SUBJECT: COMANCHE PEAK NUCLEAR POWER PLANT, UNITS 3 AND 4
DOCKET NUMBERS 52-034 AND 52-035
RESPONSES TO REQUEST FOR ADDITIONAL INFORMATION NO. 5317
(SECTION 3.7.1), NO. 5411 (SECTION 6.4), AND NO. 5465 (SECTION 2.3.1)

Comanche Peak, Units 3 and 4

RAI NO.: 5317 (CP RAI #205)

QUESTION NO.: 03.07.01-7

Figure 1 – Site Response Soil Column Analysis Results Showing Ground Surface Acceleration Response Spectra for Four Soil Profiles due to Rock Outcrop Motion Applied at Foundation Level

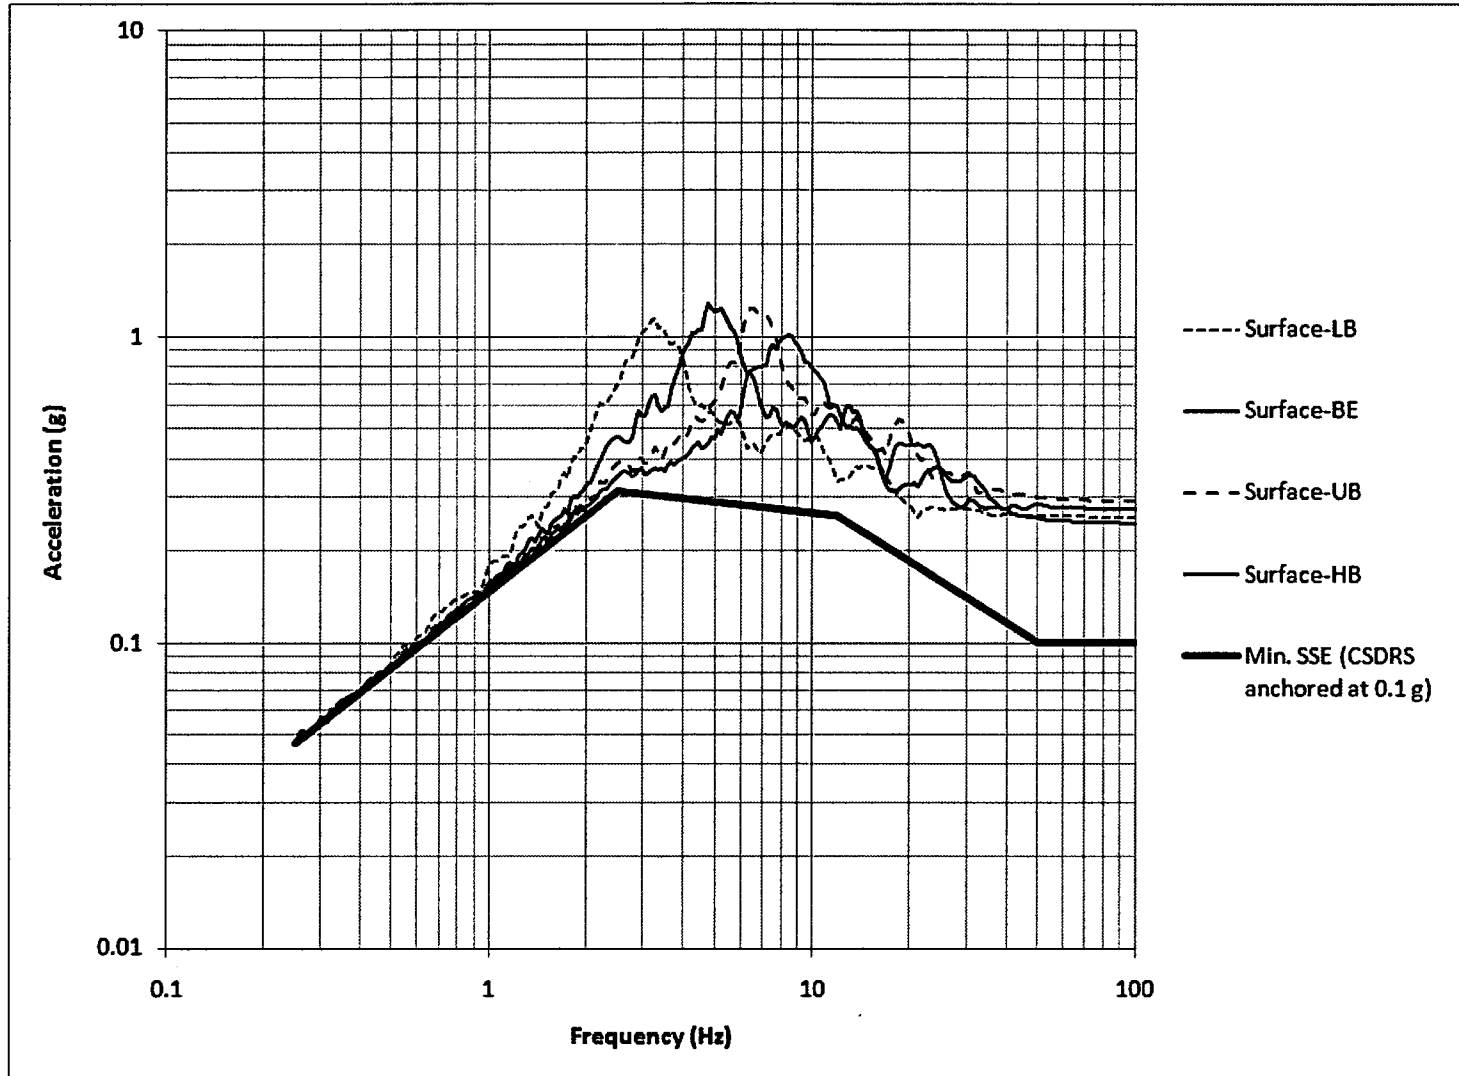
In response to RAI 3.7.1-3 Luminant has stated that the development of foundation input response spectra (FIRS) 1, FIRS 2, and FIRS 3 is consistent with the recommendations of NEI (2009) *Consistent Site-Response/Soil-Structure Interaction Analysis and Evaluation* for embedded structures that are analyzed as surface structures. To date, the soil-structure interaction (SSI) analysis performed in support of the US-APWR Standard Plant has treated embedded structures as surface structures. In contrast, in the SSI analysis of the CPNPP structures, embedded structures are analyzed as embedded structures, not surface structures.

Consequently, FIRS 1, FIRS 2, and FIRS 3 that were developed for treating embedded structures as surface structures will not generally be the same FIRS for analyzing embedded structures as embedded structures. Section 3.2.3 of NEI gives a multi-step process for developing FIRS to be used when analyzing embedded structures as embedded structures. Provide justification for using FIRS 1, FIRS 2, and FIRS 3 as the basis of comparison for determining the proper seismic input to the CPNPP structures and describe how the current approach does or does not meet the guidelines of DC/COL Interim Staff Guidance-017 (which adopts the methodology of NEI [2009]).

Figure 1 shows the horizontal ground motion acceleration response spectra (ARS) calculated in the site response analyses. The figure shows the 0.1 g CSDRS and surface ARS calculated for each of the four soil cases: lower bound (LB), best-estimate (BE), upper bound (UB) and high bound (HB) as indicated. The 0.1 g CDSRS motion was input as outcrop motion at the foundation level at top of limestone. The resulting ground surface ARS are significantly higher than the outcrop motions input at rock level.

ISG-017 and the associated NEI document require the motions applied to exceed the performance-based spectra developed at foundation level (FIRS) and at surface level (PBSRS). The performance based surface response spectra (PBSRS) corresponds to FIRS3 or FIRS4 identified in FSAR Figure 3.7-201. The input motion applied exceeds the FIRS3 and FIRS4 values by a significant margin at all frequencies. None of the spectra in FSAR Figure 3.7-201 directly represent outcrop FIRS response for embedded structures, however based on Figure 1, surface spectra are higher than the foundation level outcrop motion for this soil column. Therefore, the performance-based FIRS will be lower than FIRS3 and FIRS4
